TECH TIPS

IGNITION COILS

REFS. 155043 & 156800 | ASSEMBLY EVOLUTION

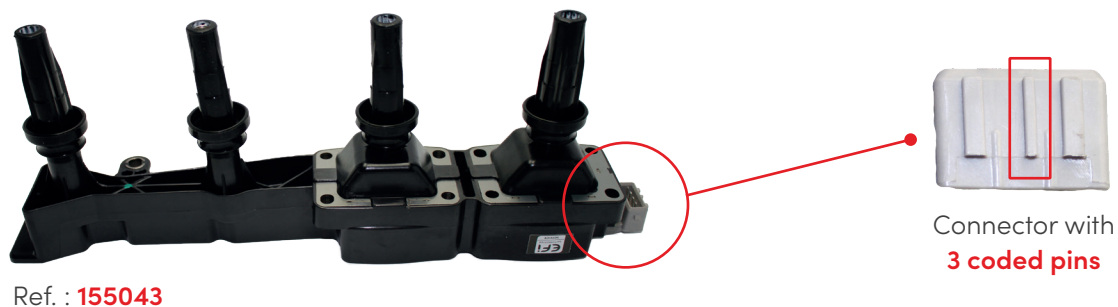
The **156800** coil matches with the OEM **597012** and **597056**. It is fitted to PSA vehicles **with a model year between May 1996 and December 2000** (older vehicles type 106 II S16 TU5J4). This coil has a **connector with 2 grooves**.

Connector with
2 coded pins

For more recent vehicle models **(from January 2001 to July 2003)**, the manufacturer has developed another coil: 155043, which has a connector **with 3 grooves - an additional coding device which means that this new coil cannot be fitted to older vehicles**. This coil corresponds to the following OEM part numbers: **5970A3** and **597081**.

Be careful not to confuse the two coils, as they are not interchangeable! The grooves on the connector make it impossible to confuse them.
